TURKEY POINT NUCLEAR GENERATING STATION UNIT NO. 3

TURKEY POINT NUCLEAR GENERATING STATION UNIT NO. 4

ATTACHMENT TO LICENSE AMENDMENT NOS. 49 AND 41
FACILITY OPERATING LICENSE NOS. DPR-31 AND DPR-41
DOCKET NOS. 50-250 AND 50-251

SAFETY EVALUATION BY THE OFFICE OF NUCLEAR REACTOR REGULATION
SUPPORTING AMENDMENT NOS. 49 AND 41 TO LICENSE NOS. DPR-31 AND DPR-41
FLORIDA POWER AND LIGHT COMPANY
TURKEY POINT NUCLEAR GENERATING STATION, UNITS 3 AND 4
DOCKET NOS. 50-250 AND 50-251

FIGURE 3.2-3

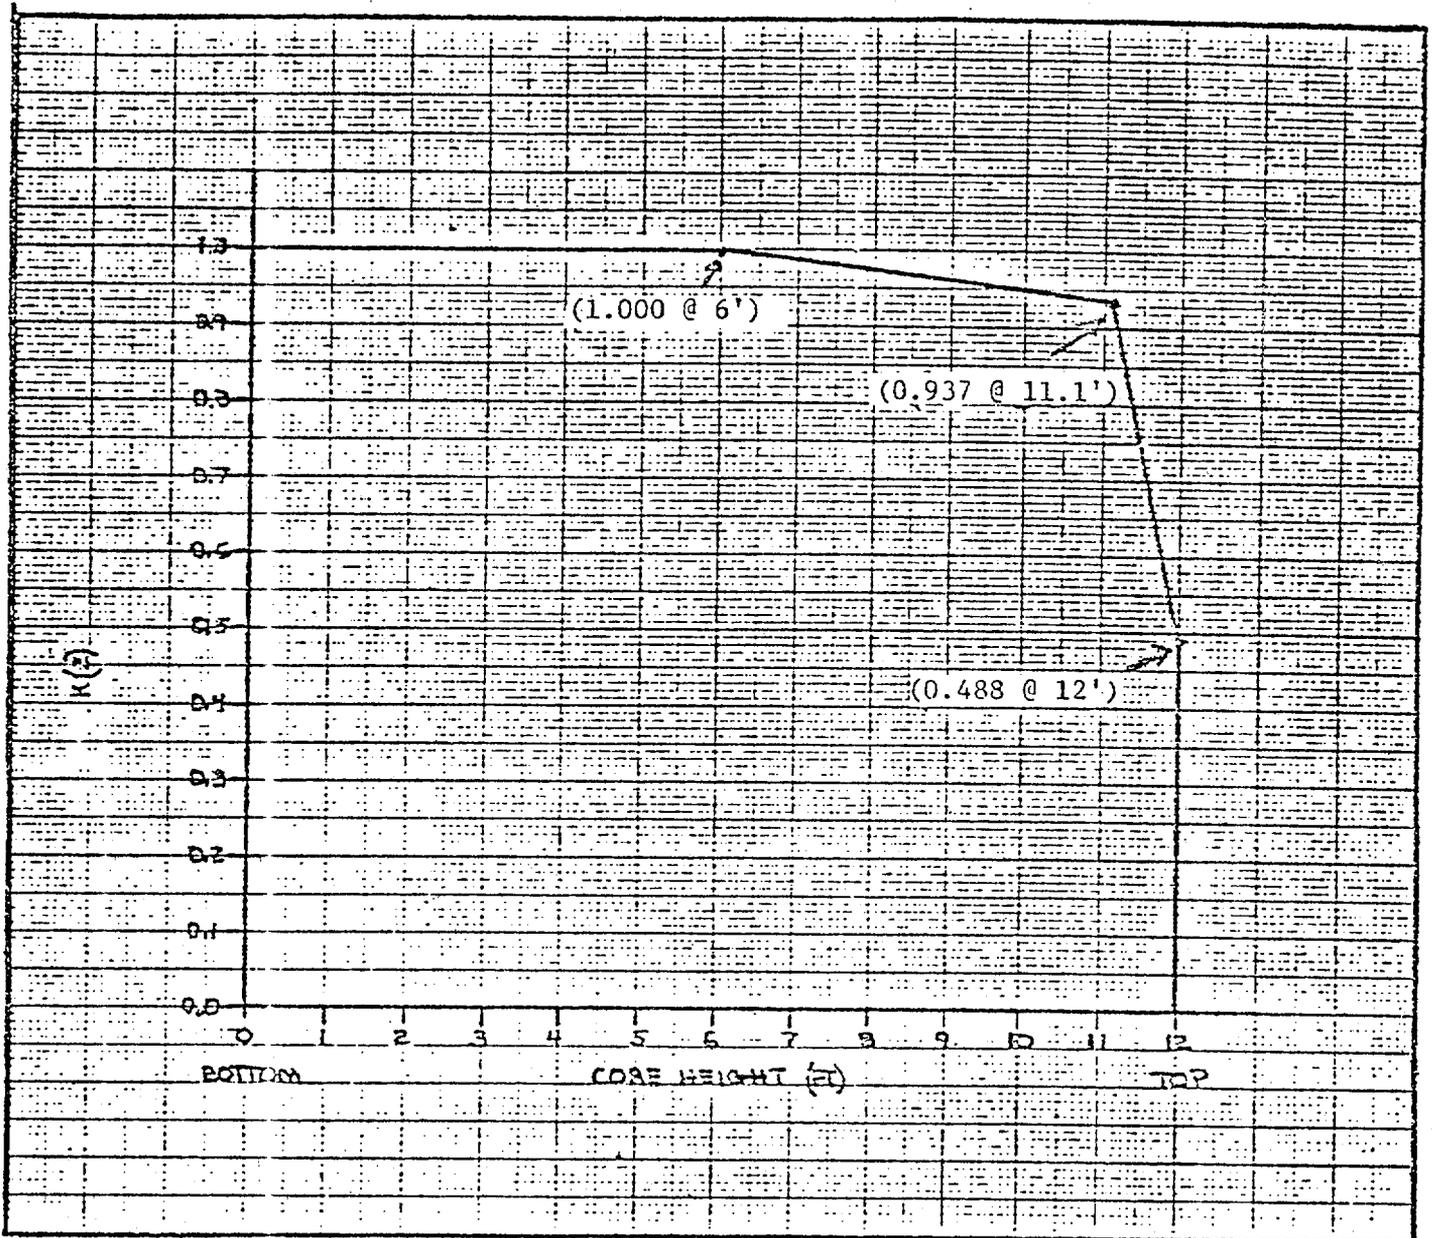
<u>Remove</u>	<u>Insert</u>
3.2-3	3.2-3
3.2-4	3.2-4
Fig. 3.2-3	Fig. 3.2-3
Fig. 3.2-3a	Fig. 3.2-3a*
-----	Fig. 3.2-3b*
B 3.2.4	B 3.2-4
B 3.2-6	B 3.2-6

Where P is the fraction of rated power at which the core is operating; K(Z) is the function given in either Figure 3.2-3 or 3.2-3a; Z is the core height location of F_q .

Figure 3.2-3a Amendment No. 49, Unit 3
Amendment No. 41, Unit 4

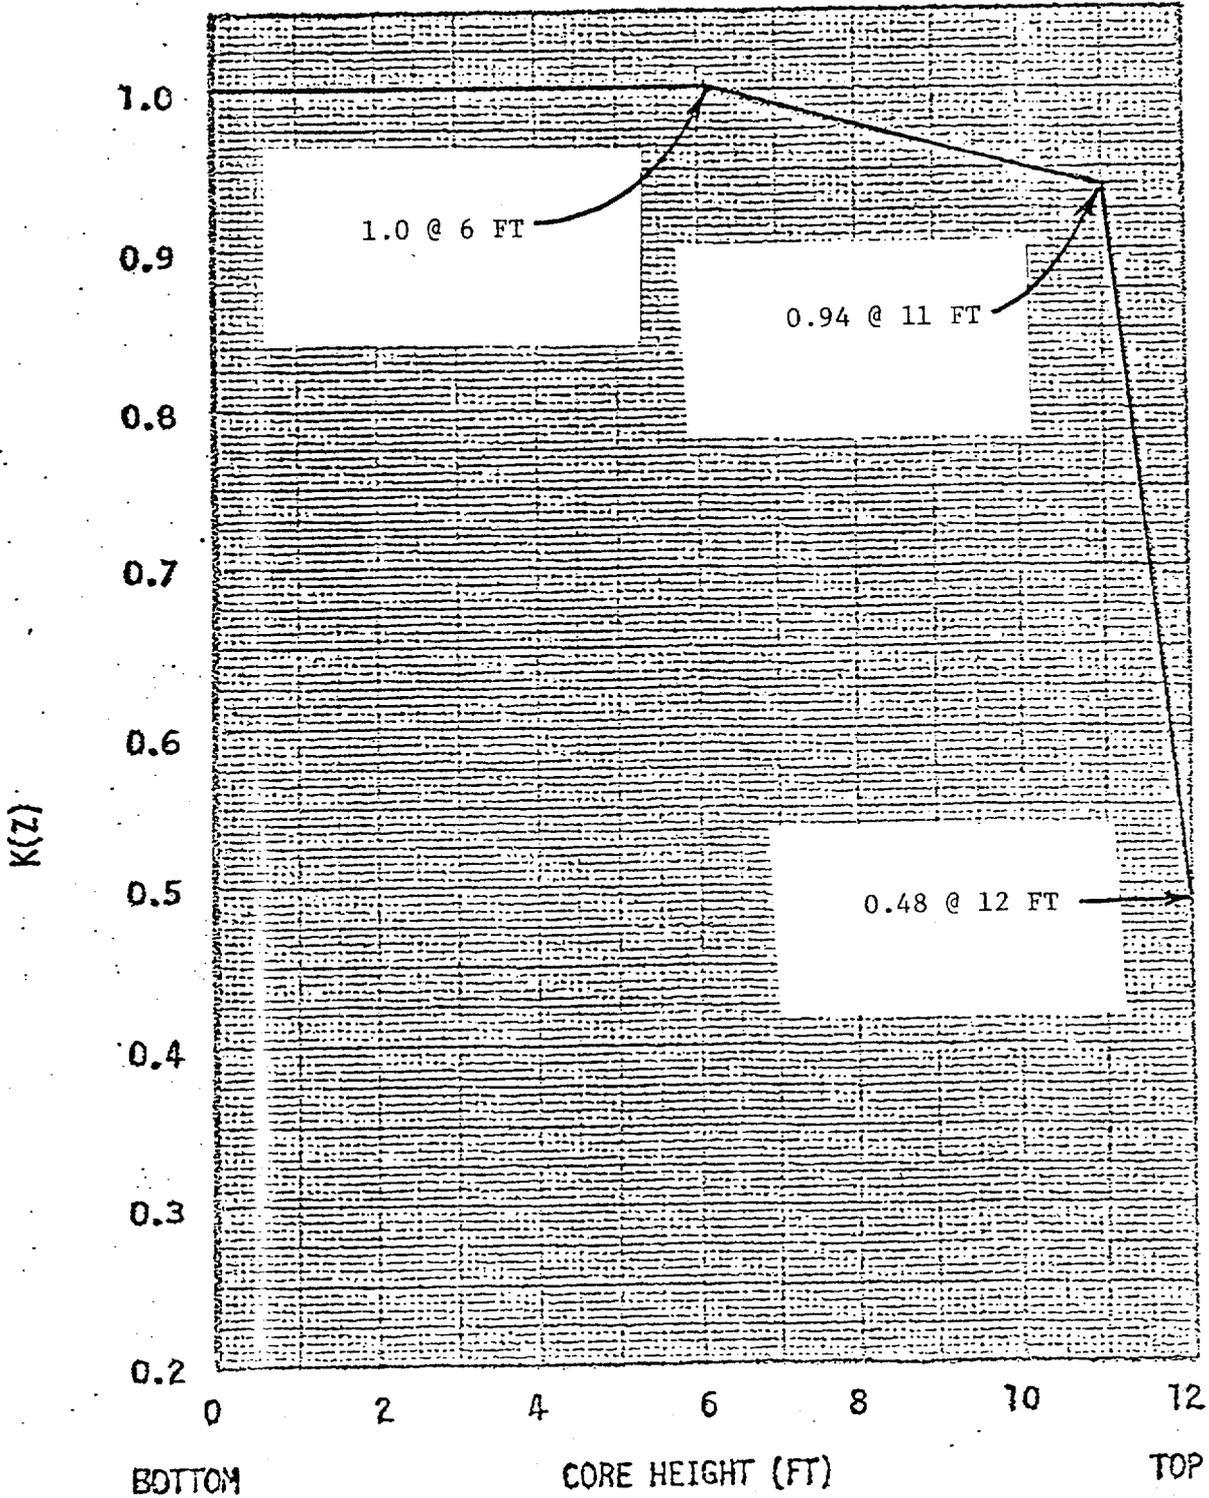
*Changes in figure number only.

HOT CHANNEL FACTOR - NORMALIZED
OPERATING ENVELOPE (for
steam generator tube plugging
22% and $F_q = 2.10$)

FIGURE 3.2-3b

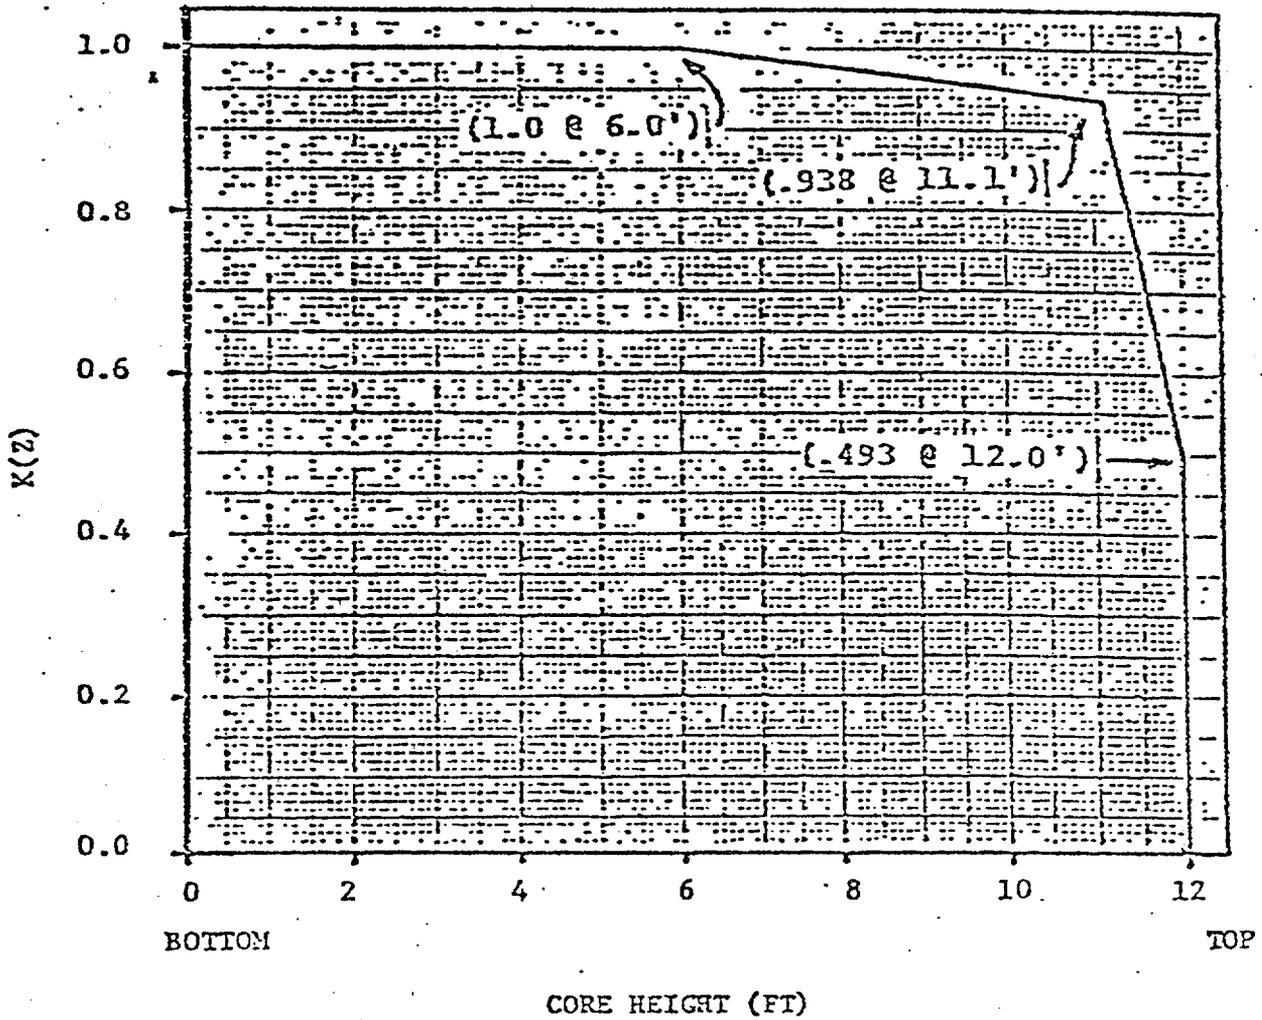
HOT CHANNEL FACTOR-NORMALIZED
OPERATING ENVELOPE (FOR STEAM
GENERATOR TUBE PLUGGING $\leq 25\%$ and $F_q=2.03$)

Where P is the fraction of rated power at which the core is operating; K(Z) is the function given in Figure 3.2-3b; Z is the core height location of F_q .
